**Date:** 12/3/2009 9:23 AM **Subject:** RE: TID A2PP

09-AFC-2

Subject: TID A2PP

Attachments: NH3 Piping Sketch.pdf; NH3 Piping Sketch.pdf

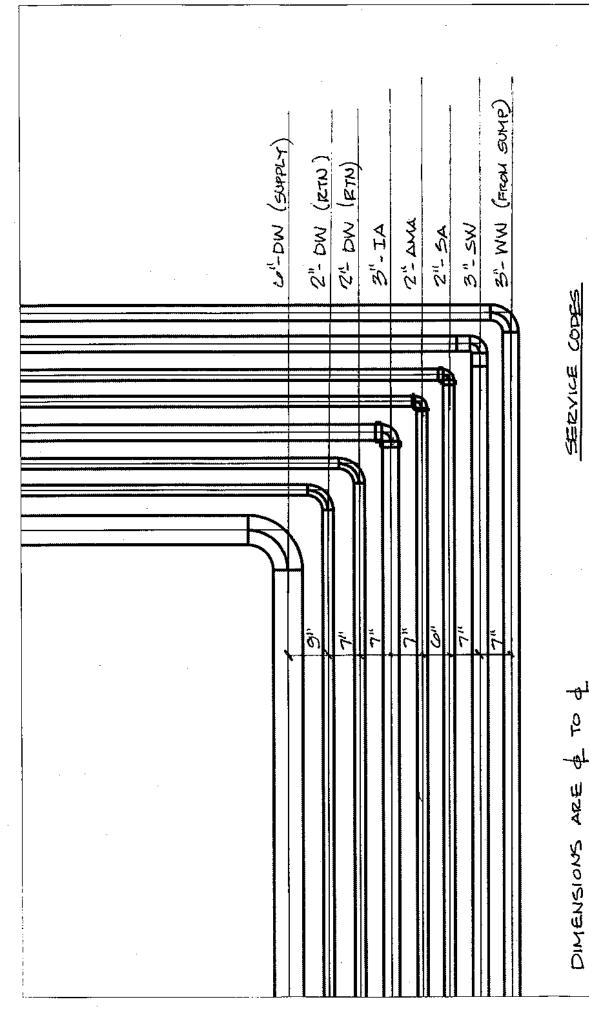
Please find out what the "other pipes" that will be buried within or "near" the same trench as the anhy ammonia pipe and what the distance & fill materials will be between them. In other words, will the pipes be separated by inches? How many inches? Will the fill material be pea-size gravel, sand, or re-filled with excavated soil?

3. Will anything else be located in the same trench as the ammonia line?

Alvin - Attached is a sketch which identifies the other pipelines that would be located within the same trench as the ammonia line. It also shows the distance between the lines.

Regarding the fill material, existing or native soil, course sand, fine gravel, or other suitable material may be used consistent with construction specifications and as approved by the geotechnical consultant.

The piping will be buried near other buried piping but not close to any electrical cabling.
